From: Razavi, Mohammad (EEC)
To: 'Danny Caudill'
Cc: Eneje, Jerome (EEC); 'Timothy C. Howard'; Boles, Tricia (EEC)
Subject: 807-0365 NW

From: Razavi, Mohammad (EEC)
Sent: Thursday, December 04, 2008 1:39 PM
To: 'Danny Caudill'
Subject: 807-0365 NW Three (3) requests

This form supplies all technical information in regard to the mining and reclamation plan for the permit. It shall be filed in conjunction with MPA-01 for all original and amendment applications.	PERMIT NUMBER <u>807-0365</u>
	DSMRE ID NUMBER <u>000095</u>

Appolo Fuels, Inc.	
Permit No. 807-0365 Worst Case Backfill Stability Analysis Cross Section 12 Attachment 26.3.A	
Scale: 1" = 100'	Page No. 1 of 1
Prepared by: Howard Engineering & Geology, Inc.

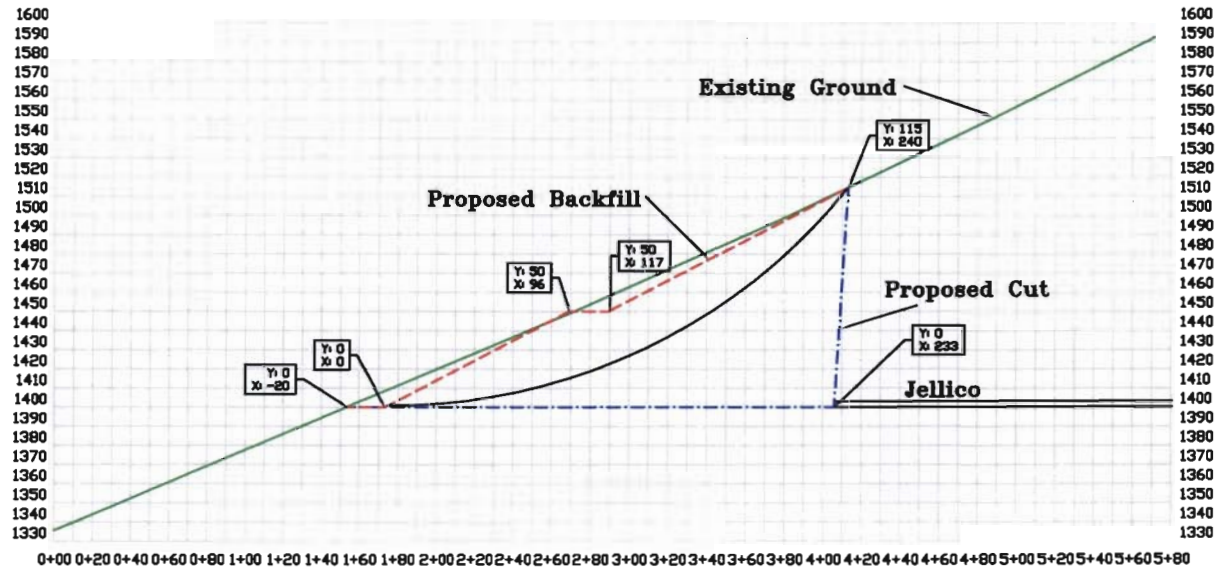
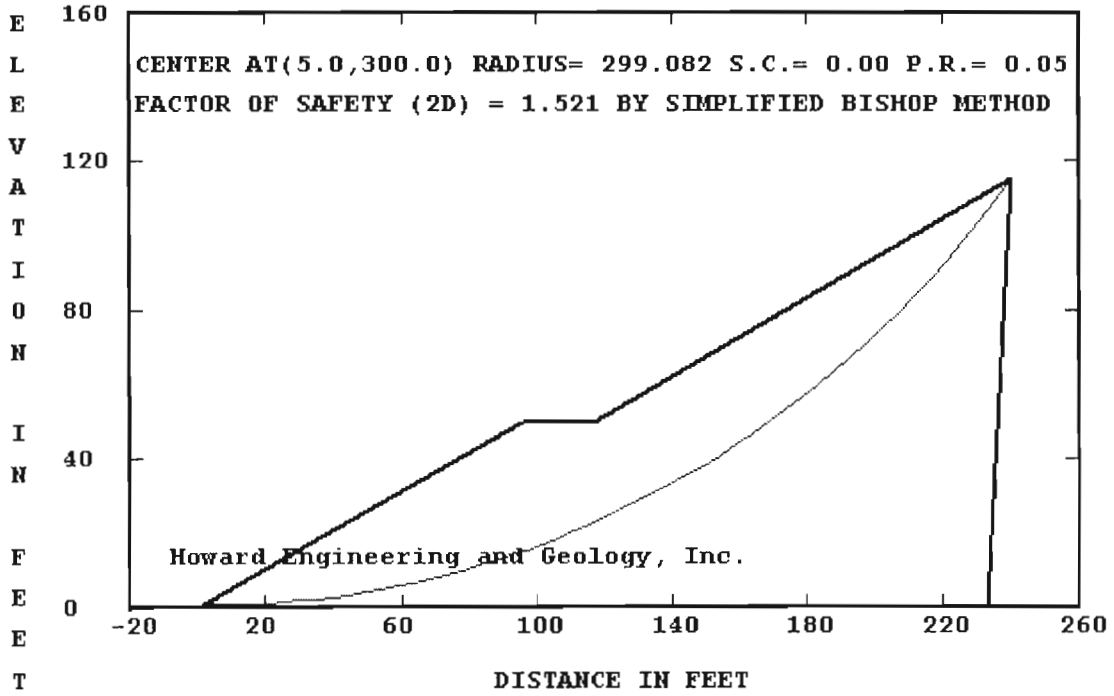
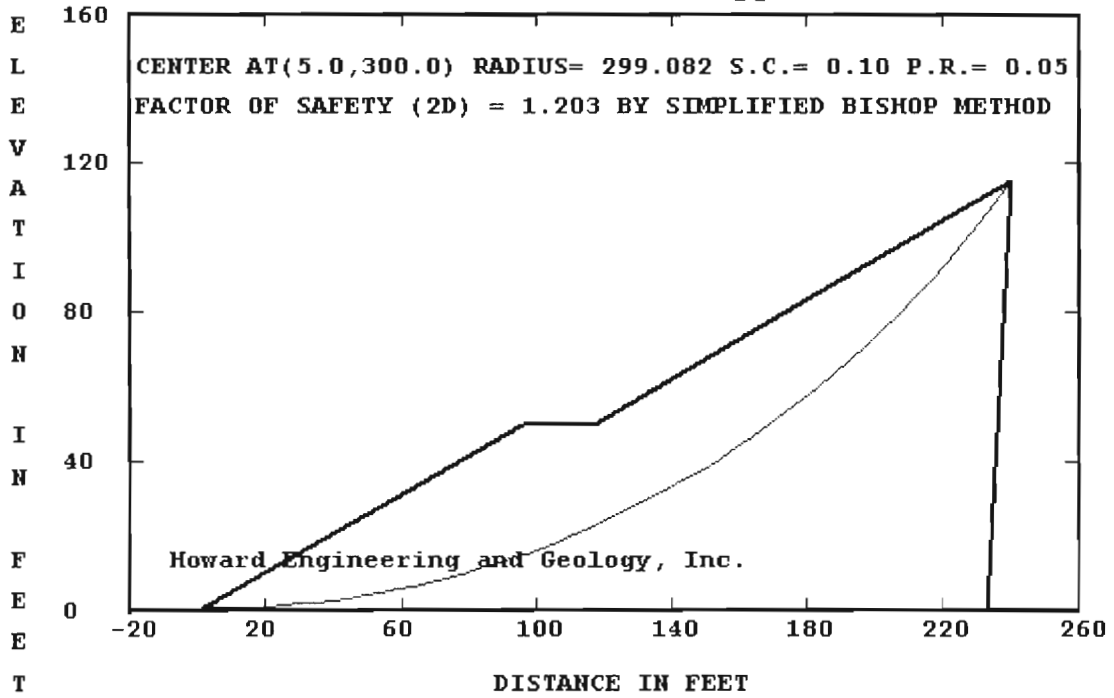
1. REAME run (Plane failure): Please replace the pore-pressure of 0.05 with 0.10 to obtain the appropriate safety factors.
2. Pond 6 (Pre-Mine Discharge): P6-25yr-Pre-Rev1.sc4 is using 86.08-ac instead of 30.00-ac (as used in the during-mining files).
3. Short of Ponds 4 & 7, the rests have flooding potentials; regardless of 10%-or-less, please ask Mr. Howard (whom has signed/stamped these articles) if there would be adverse impacts on any structures (residential & non-residential) due to increase in the flooding potential.

5. **Item 26.3:** Attachment 26.3.A: Since no interface material is modeled into REAME (circular failure), please make clear whether the applicant is excavating to bedrock for the footprint of the fill.
6. **Item 31.3:** Ponds 1, 2, 3, 4, 5, 6, & 7 (SEDCAD, Pre-mining): They all have CN=86, 79, etc. & mining land conditions; please clarify; if decide to replace them with CN=73, please discuss the flooding potential (if any).

1. REAME run (plane failure): The pore-pressure of 0.05 has been replaced with 0.10 as requested.
2. Pond 6 (Pre-Mine Discharge): The acreage has been corrected to 30.00 for the SEDCAD run.
3. According to Department Policy if the pond 25 year SEDCAD run is within 10% of the Pre-Mine SEDCAD run we do not have to address any flooding potential.
